MICROCHIP PIC12(L)F1822/PIC16(L)F1823

PIC12(L)F1822/PIC16(L)F1823 Family Silicon Errata and Data Sheet Clarification

The PIC12(L)F1822/PIC16(L)F1823 family devices that you have received conform functionally to the current Device Data Sheet (DS40001413E), except for the anomalies described in this document.

FIGURE 1: INSTRUCTION CYCLE DELAY CALCULATION EXAMPLE

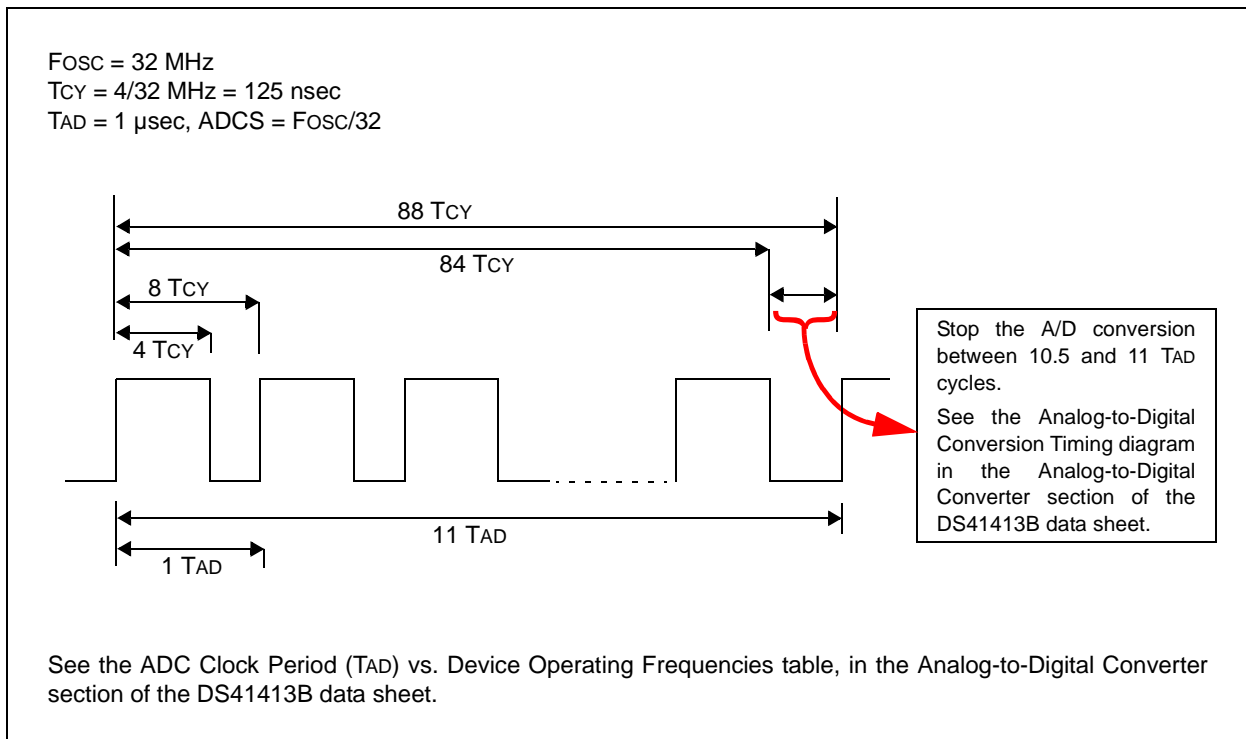
Under certain device operating conditions, the ADC conversion may not complete properly. When this occurs, the ADC Interrupt Flag (ADIF) does not get set, the $\overline{\text{GO/DONE}}$ bit does not get cleared and the conversion result does not get loaded into the ADRESH and ADRESL result registers.

Method 2: Provide a fixed delay in software to stop the A-to-D conversion manually, after all 10 bits are converted, but before the conversion would complete automatically. The conversion is stopped by clearing the $\overline{\text{GO/DONE}}$ bit in software. The $\overline{\text{GO/DONE}}$ bit must be cleared during the last $\frac{1}{2}$ TAD cycle, before the conversion would have completed automatically. Refer to [Figure 1](#) for details.

In [Figure 1](#), 88 instruction cycles (TCY) will be required to complete the full conversion. Each TAD cycle consists of 8 TCY periods. A fixed delay is provided to stop the A/D conversion after 86 instruction cycles and terminate the conversion at the correct time as shown in the figure above.

Note: The exact delay time will depend on the choice of FOSC and the TAD divisor (ADCS) selection. The TCY counts shown in the timing diagram above apply to this example only. Refer to [Table 3](#) for the required delay counts for other configurations.
